DSP-25007

Walker Mill Business Park Lot 15 Block B

STAFF REPORT

SUBJECT: Detailed Site Plan DSP-25007
 Type 2 Tree Conservation Plan TCP2-014-2025
 Walker Mill Business Park Lot 15 Block B

Figure 1: Detailed Site Plan - Phase 1

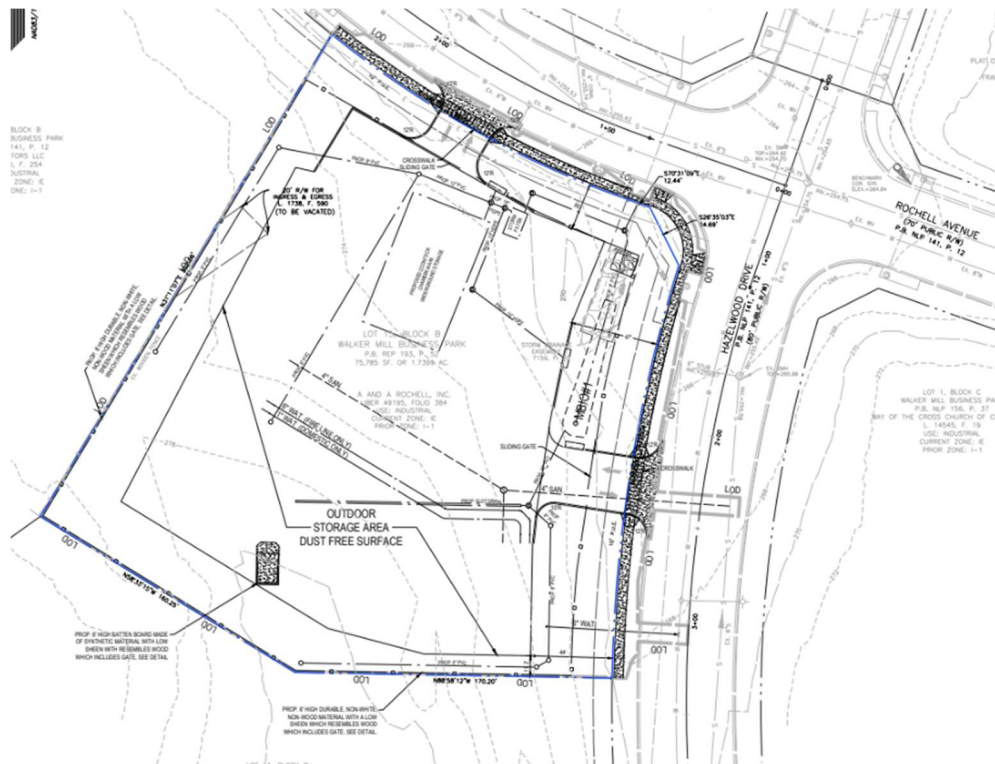
Note: *No parking spaces are shown in Phase 1 of the submitted plans, although there is room within the storage area for the required spaces. A condition has been included herein requiring the applicant to show the required parking for Phase 1 prior to certification of the DSP. There is no loading space requirement for contractor storage yards.

- c. Identify plan sheet A72058 as Phase 2 of development.
 - d. Add wheel stops to any parking spaces abutting loading spaces.
 - e. Show the required parking spaces, including any Americans with Disabilities Act accessible spaces, on the Phase 1 site plan.

Figure 2: Detailed Site Plan - Phase 2

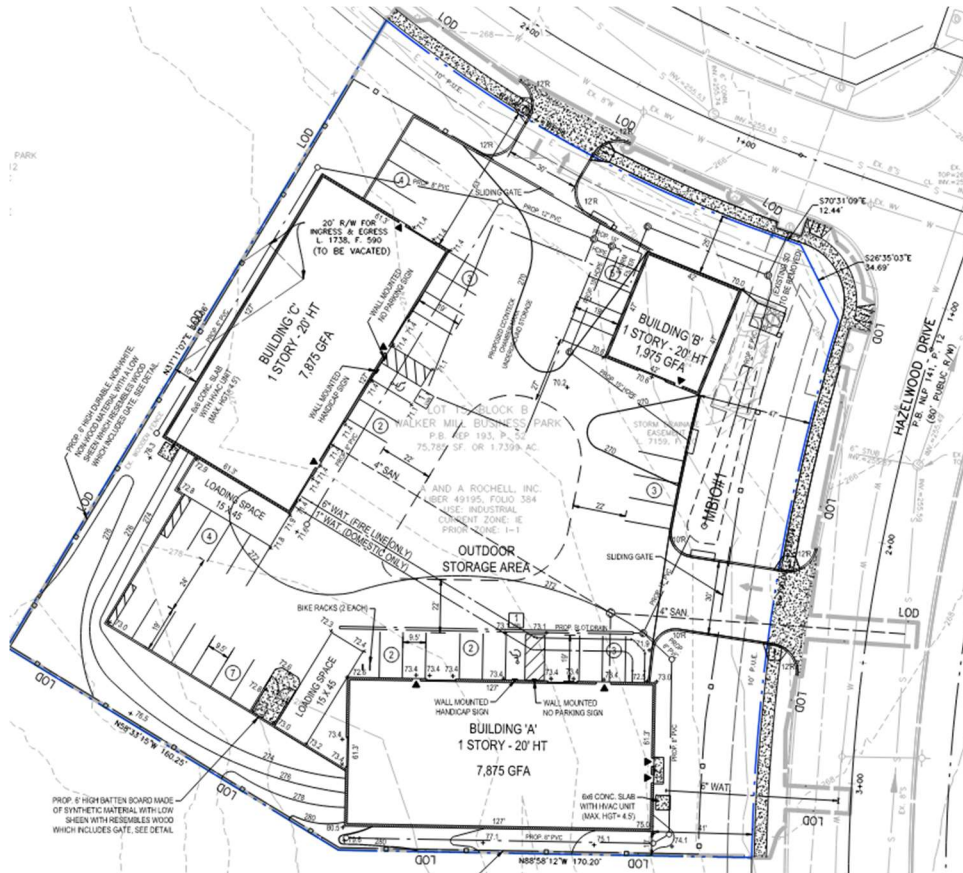
- f. Correct General Note 7 to identify the use as a contractor's office and state a total of 34 standard parking spaces and 2 handicap van-accessible spaces, as shown on the plans for Phase 2.

Figure 3: Proposed Architectural Elevations for Building A. Similar architecture is proposed for Buildings B and C.

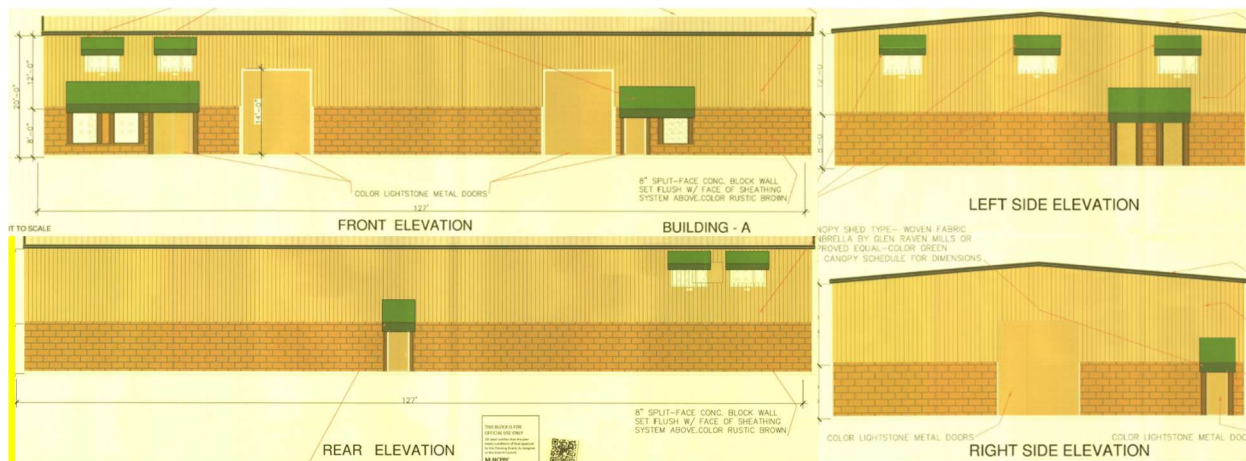
- g. The applicant shall revise the elevation drawings for the project to create more visual interest in the facades, including varied fenestration on the first level and awnings over the windows and doors in a style as represented in the exhibit submitted by the applicant for the “MBM Metal Buildings.”

Response: Architectural elevations were approved with DSP-03085 and are not proposed to be revised. For reference, the prior approved architectural elevations are included with this application and given the revision number DSP-03085-02.

Figure 4: Cross Section of Proposed Storage Yard

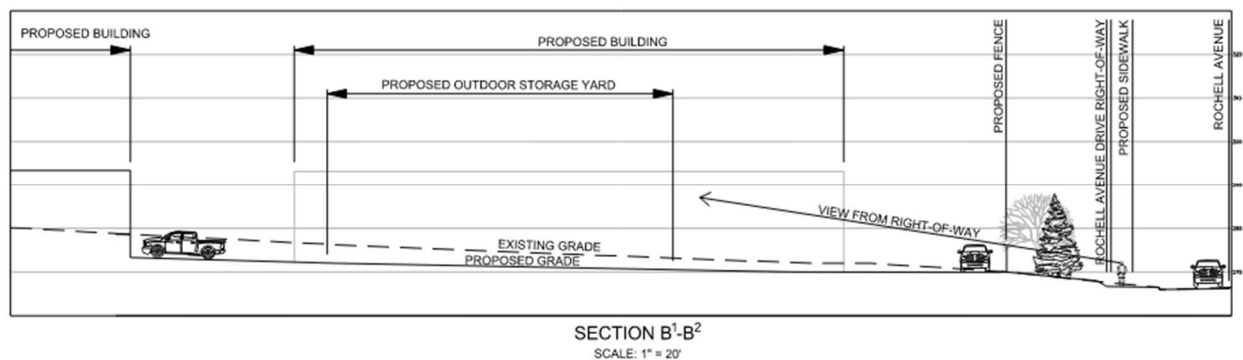
- C. Provide cross-sections through the subject site to demonstrate that any area of outdoor storage visible from any adjacent right-of-way shall have the solid wood fence specified in condition 1. a.**

The cross-section exhibit submitted with the DSP demonstrates that the outdoor storage area will be sufficiently screened from the public ROW for Phase 2. A condition is included herein requiring a similar exhibit be submitted prior to certification for Phase 1, in accordance with this condition.

- b. Add a general note to state that outdoor storage shall not be visible from the street, in accordance with Section 27-469(c)(1) of the prior Prince George's County Zoning Ordinance, and provide an exhibit demonstrating conformance to this Section for Phase 1.

TYPE II TREE CONSERVATION PLAN

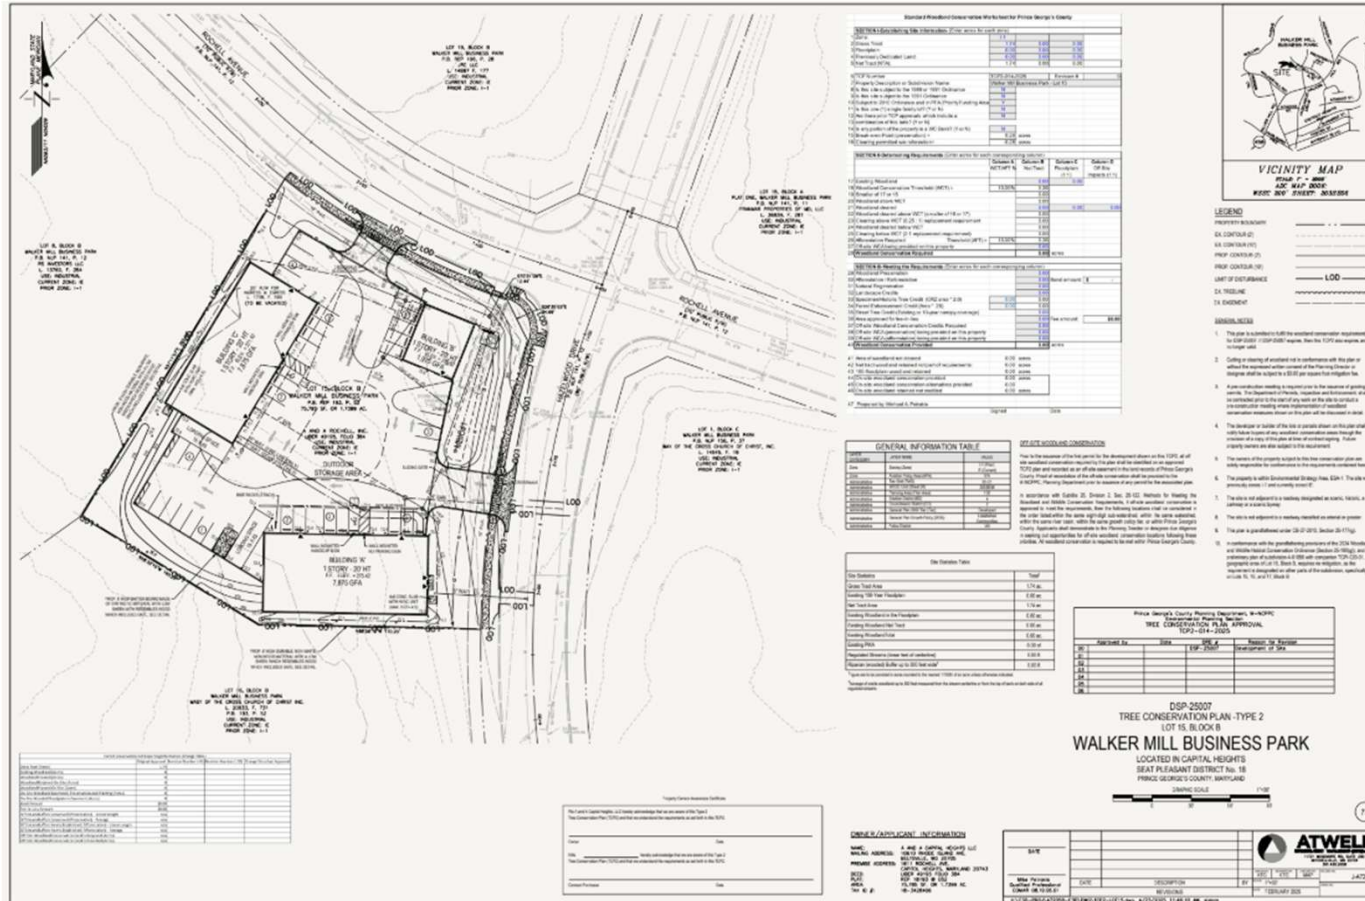
- h. Submit the revised approved stormwater management concept plan.
2. Prior to certification of the detailed site plan, the Type 2 tree conservation plan shall be revised as follows, in accordance with the 2018 Environmental Technical Manual (ETM):

- a. The general note for the utilization of off-site woodland conservation credit shall be revised to be reflective of standards as shown in the ETM.
- b. The property owner's awareness block shall be signed and dated.
- c. Revise General Note 10 to read as follows:

"In conformance with the grandfathering provisions of the 2024 Prince George's County Woodland and Wildlife Habitat Conservation Ordinance (Section 25-199(g) of the Prince George's County Code), and Preliminary Plan of Subdivision 4-01056, with companion Type I Tree Conservation Plan TCPI-020-01, the geographic area of Lot 15, Block B requires no mitigation as the requirement is designated on other parts of the subdivision, specifically on Lots 15, 16, and 17, Block B."
